The University of Vermont
DEPARTMENT of FACILITIES DESIGN
and CONSTRUCTION

ADDENDUM NUMBER TWO
On Campus Multi-Purpose Center
March 21, 2017

LEVEL ONE

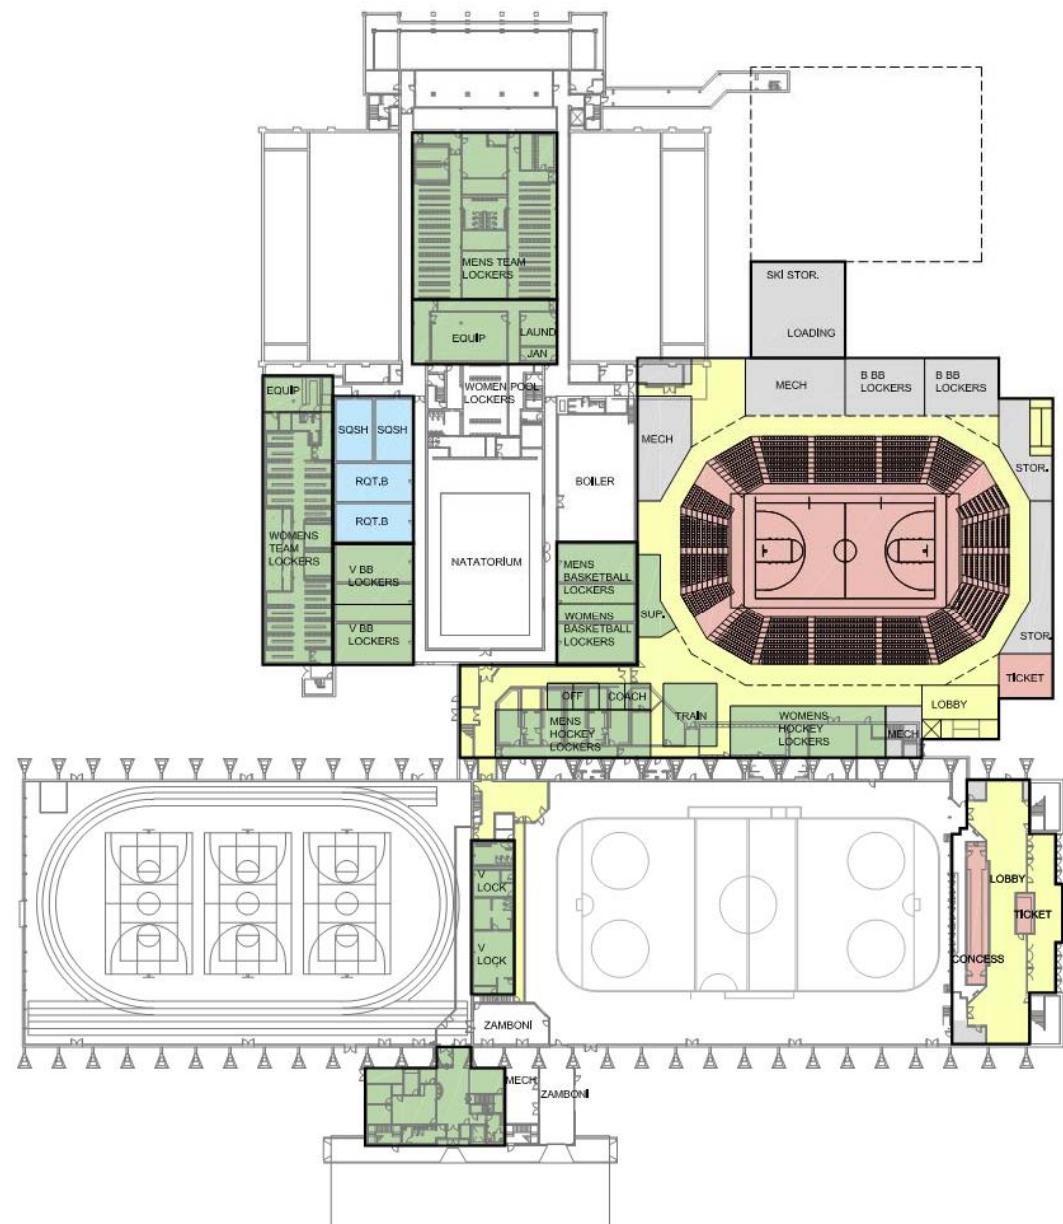
Q21. Is there a breakdown of the 86,000 SF wellness component?

A21. There is not a tabular program breakdown of the 86,000 SF wellness component, but the zone displayed in the overall plan view in the RFP attachment, together with the three levels of PFG plans provided as an additional attachment herein, clearly

displays the assumed functions that have been graphically depicted in the plan. The current Patrick Gym will be renovated into three recreation courts with a suspended running track and new women's/men's locker rooms; the current strength and conditioning space will be renovated into a MAC Court, and the new northern addition will become a combination of multipurpose spaces and fitness equipment areas.
